**CITY OF WEST DES MOINES
STAFF REPORT COMMUNICATION**

ITEM: Valley Junction Mixed Use, 304 5th Street – Approve Site Plan to allow construction of a 10,559 gross square foot mixed use structure – Junction Development Catalyst, LLC – SP-005043-2021

Resolution: Approval of Site Plan

5 - SITE SHEET

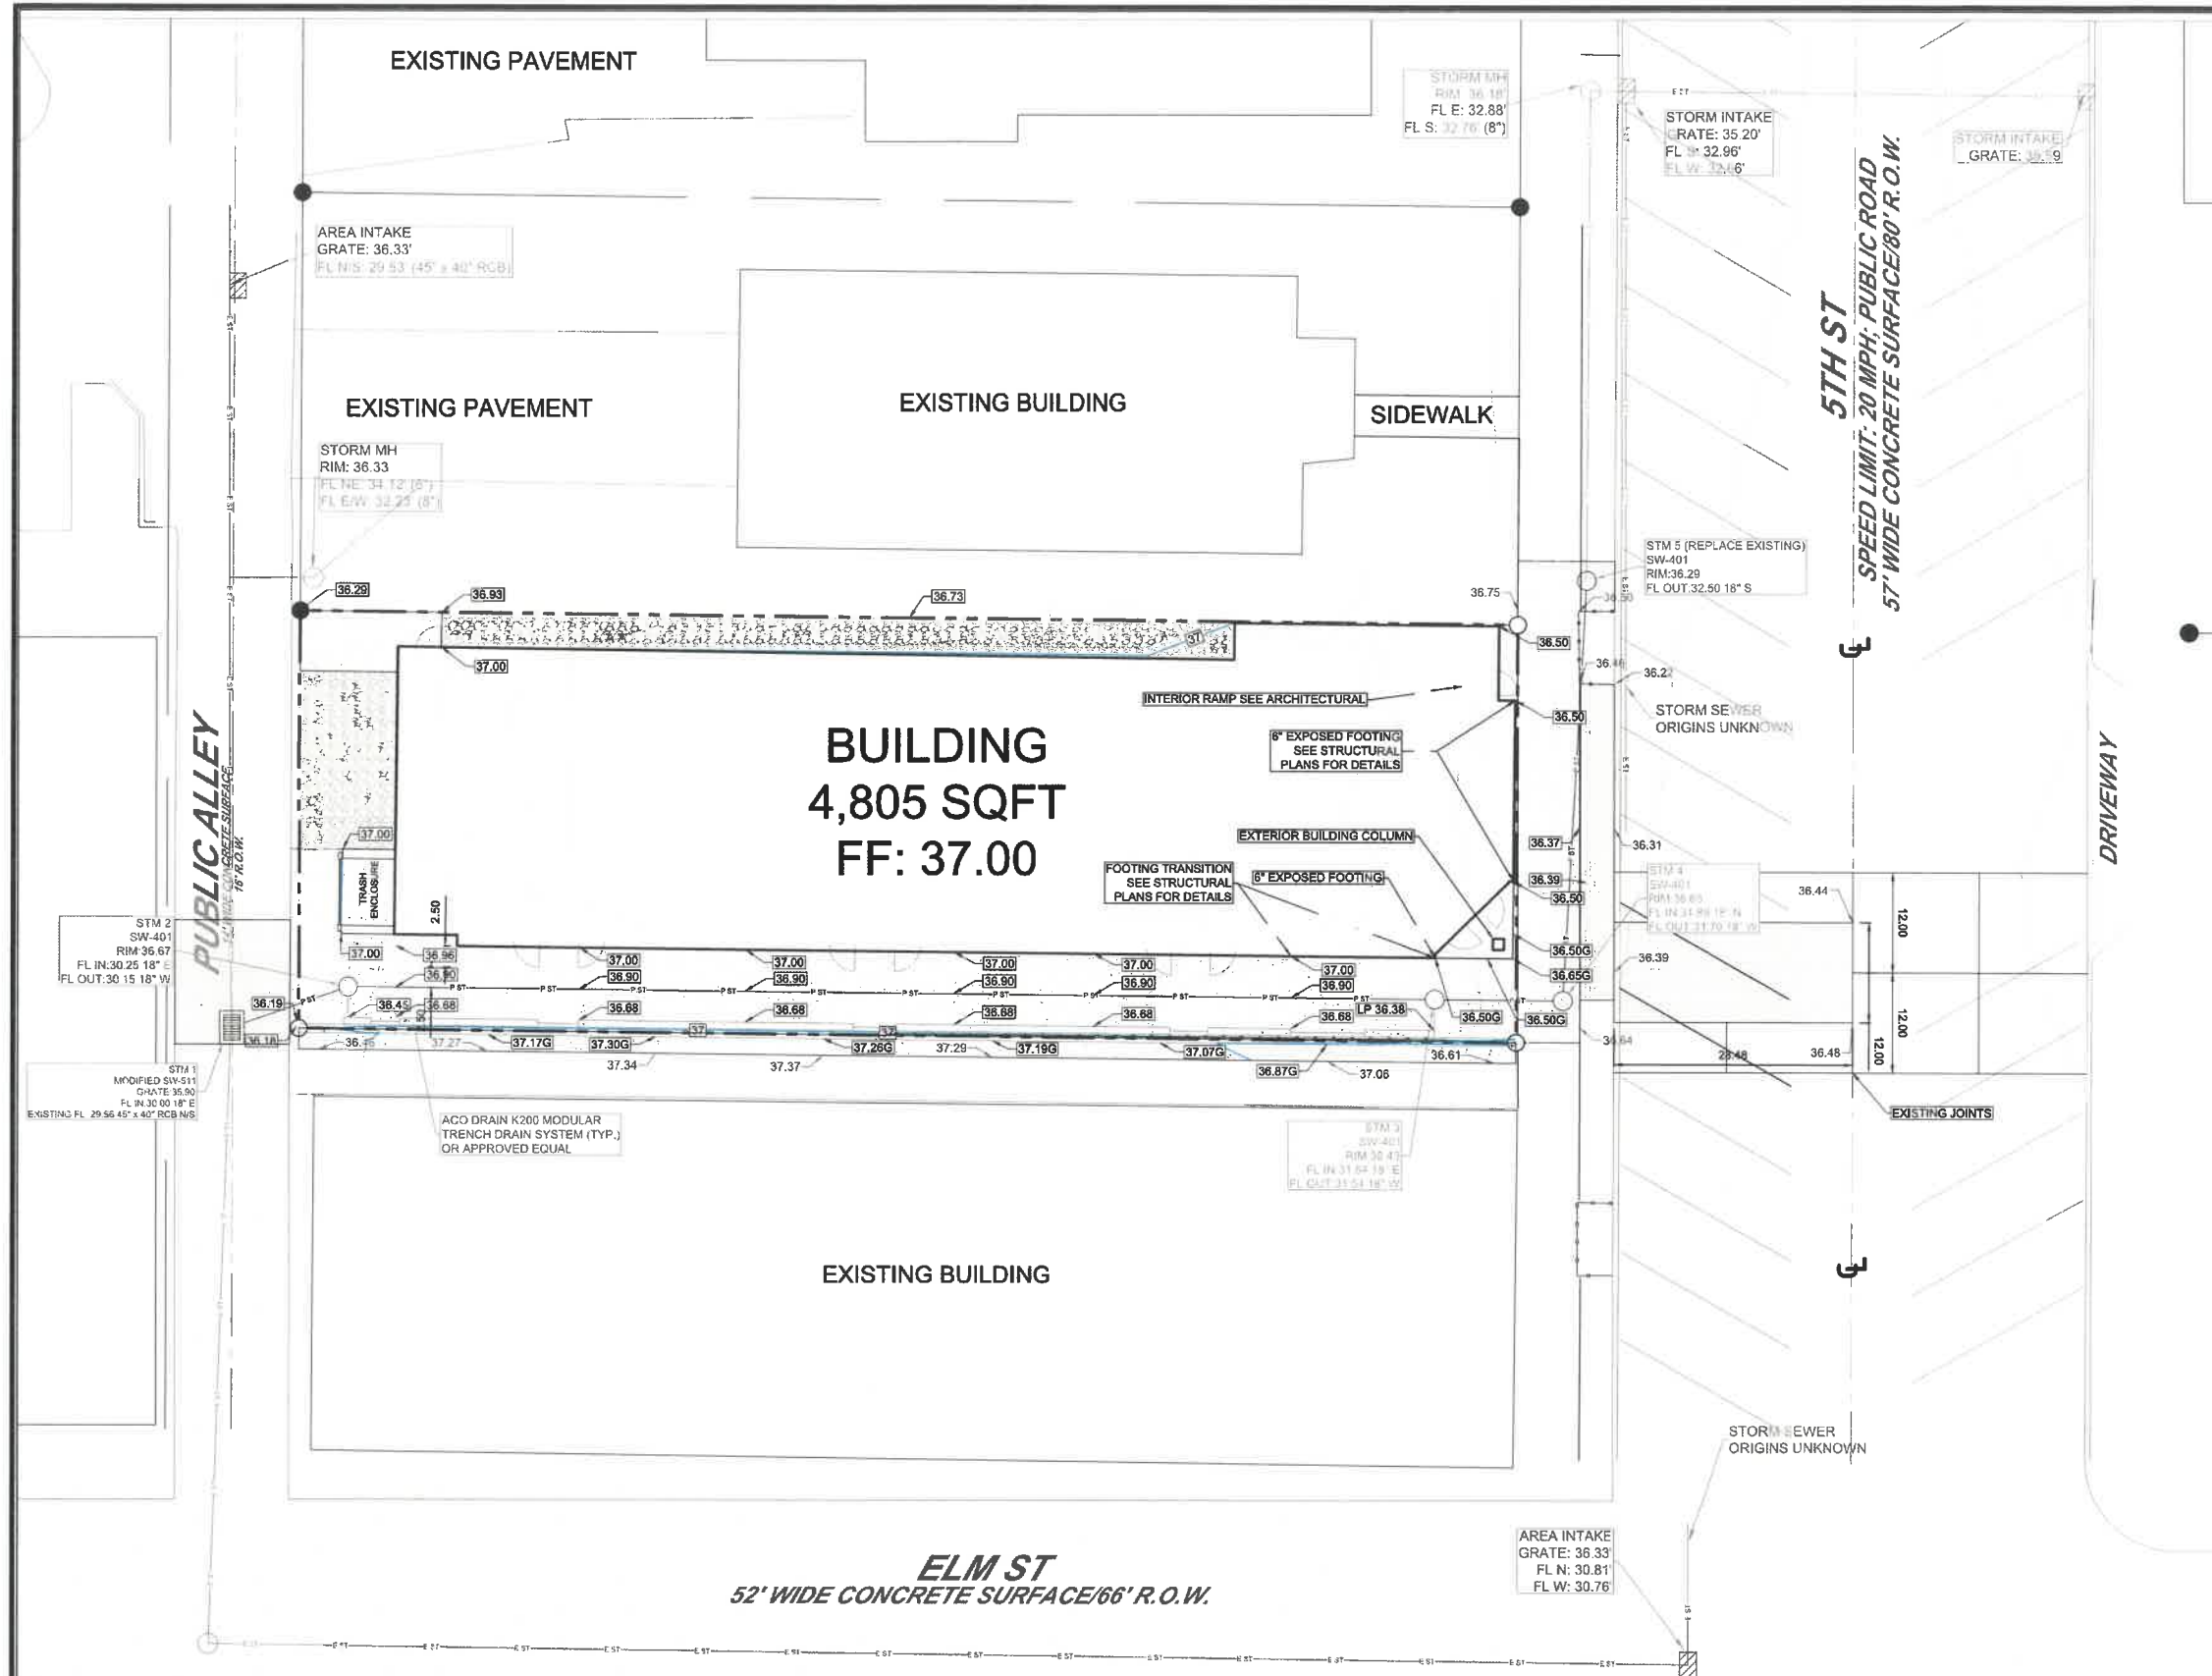
- **Construction & Staging:** The applicant is indicating that construction activities will extend outside of the property and temporary construction easements are shown on the Site Plan. The City is not approving the easements as part of the site plan and it is the responsibility of the applicant to obtain written consent from the property owners for the easements. Copies of these easements will need to be provided to the City prior to the start of construction. In addition, with the multiple construction projects going on in the vicinity and the special events in the district scheduled for this summer and fall, the applicant is being asked to submit a construction staging plan for review. Lastly, the applicant for the project has been reminded to be considerate of disruptions within the Valley Junction area during

- Screening: Due to tight site conditions and required clear spacing, the applicant is requesting a waiver of screening requirements for the transformer. The landscape screening proposed for the gas meters on the north side does not effectively screen the meters. Although the tight site does present challenges with fully screening mechanical equipment, staff believes additional measures can be taken to provide more effective screening. A condition of approval that the applicant continue to work with staff on the screening, with an acceptable solution determined prior to issuance of any building permit is being recommended by Staff.

1. Prior to issuance of any building permit, the applicant providing to the City copies of executed construction easements for off-site activities and a construction staging plan identifying on-site and off-site areas for staging of construction materials and equipment, contractor parking and areas of the public street, alley or sidewalk that will be barricaded for construction.

4. The applicant continuing to work with staff on the screening of the mechanical equipment, with an acceptable solution determined prior to issuance of any building permit.

SHEET TITLE:
EXTERIOR ELEVATIONS

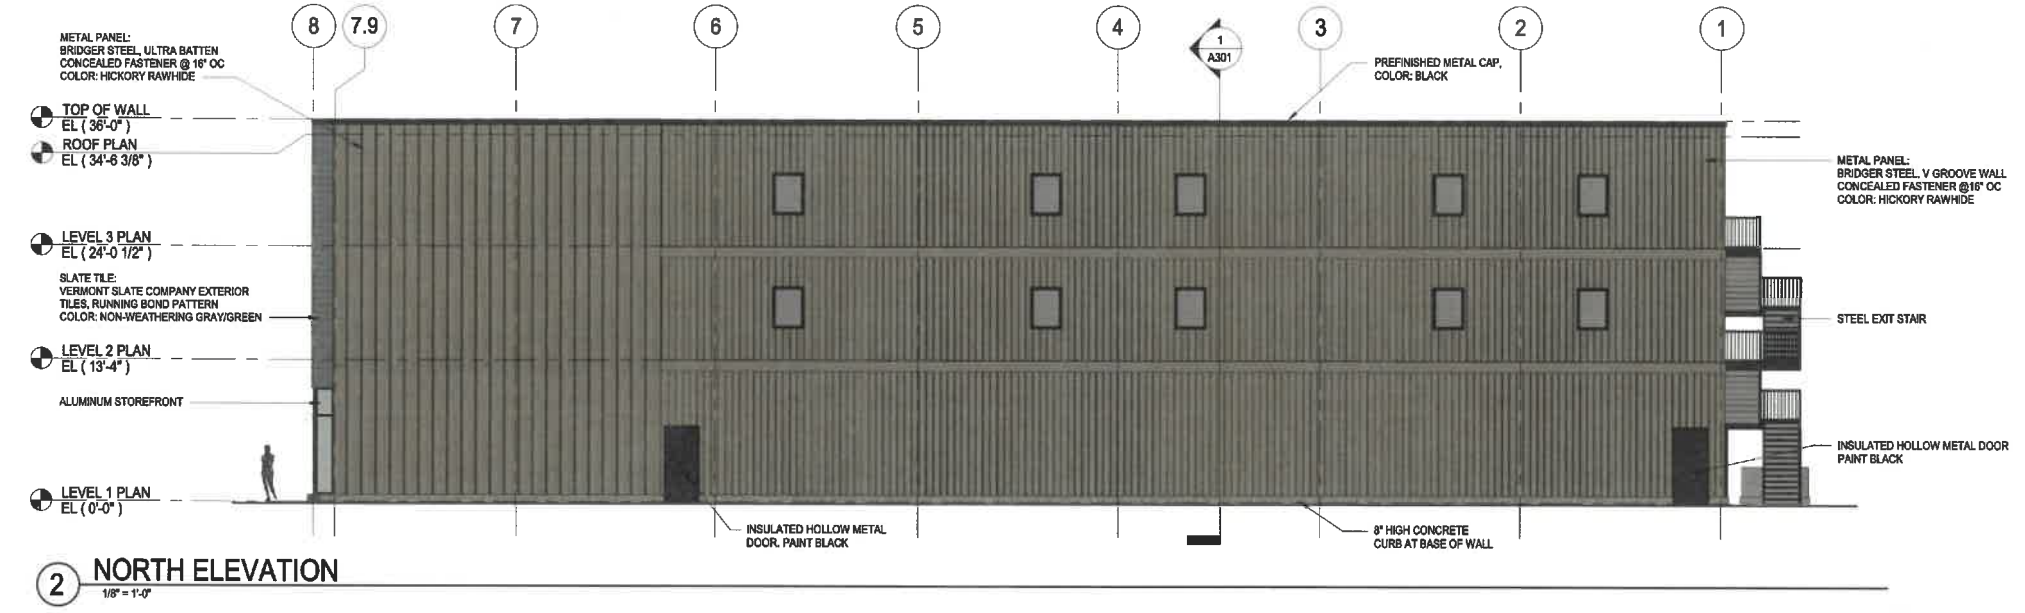
- Building Architecture: The proposed building is three stories in height in between two one-story commercial buildings. The majority of the building is setback four feet from the north property line and ten feet from the south property line to mitigate the bulk of the three-story mass against these one-story buildings. The east (5th Street) façade is primarily storefront windows opening up to a commercial space on the main floor to engage pedestrians and activate the street. The building is modern in design and details but openings in the façade do echo the store front and window configuration of the turn of the century buildings in the district. Exterior materials and color choices are new to the district but were chosen to mimic the character of traditional building materials. Primary cladding material on the east and south elevations is slate applied in a running bond pattern, picking up the pattern and variation of brick. Metal siding comprises the primary cladding material on the north and west elevations with two different profiles, a board and batten pattern and a “v groove” pattern typical of wood siding. The darker material choices do align with the colors of the new buildings being constructed on the east side of 5th Street. The north and west elevations utilize multiple smaller windows and the batten and v-groove patterns add interest to what could be long blank walls.
